POST OCCUPANCY EVALUATION

HOBSONVILLE POINT PRIMARY SCHOOL, HOBSONVILLE POINT, AUCKLAND

July 2015

Figure 5

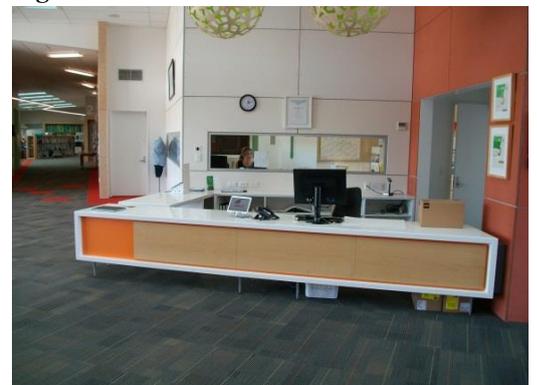
- The main entrance located adjacent to the road intersection is welcoming and directly connected to the pedestrian pathway from steps or side ramp. See Figure 5.

Figure 12

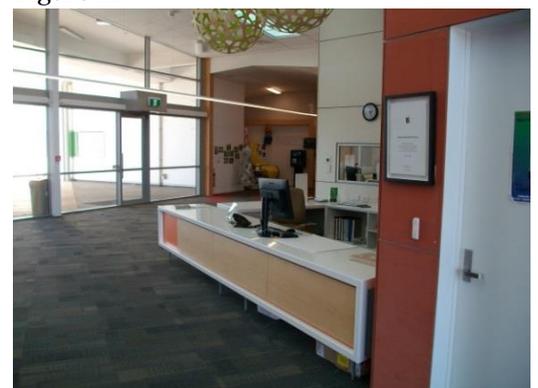
- The main entrance initially had automatically operating doors opening into the prevailing wind, manual doors have been retrofitted to mitigate the wind tunnel impact on reception. In strong wind conditions the main entrance doors are locked and visitors directed to the rear courtyard entrance as the manual doors cannot be safely operated. See Figure 12.

- The irregular building form and raised playing field prevents visual access to significant areas of the grounds. See Figure 13.
- Reception is located behind a meeting room without direct visual access to the main entrance and is rarely used with staff located in the administration area behind. See Figure 12.

- The foyer is a large space, reception does not overlook the main entrance and this area is the open connection between the Multipurpose Hall Space and the regular teaching spaces. Consider the introduction of a lobby with additional doors to protect the foyer from the prevailing wind, reconfiguration of reception to easily overlook the main entrance and the installation of a partition system to secure the regular teaching space from the foyer for after-hours use of the Hall Multipurpose Space.
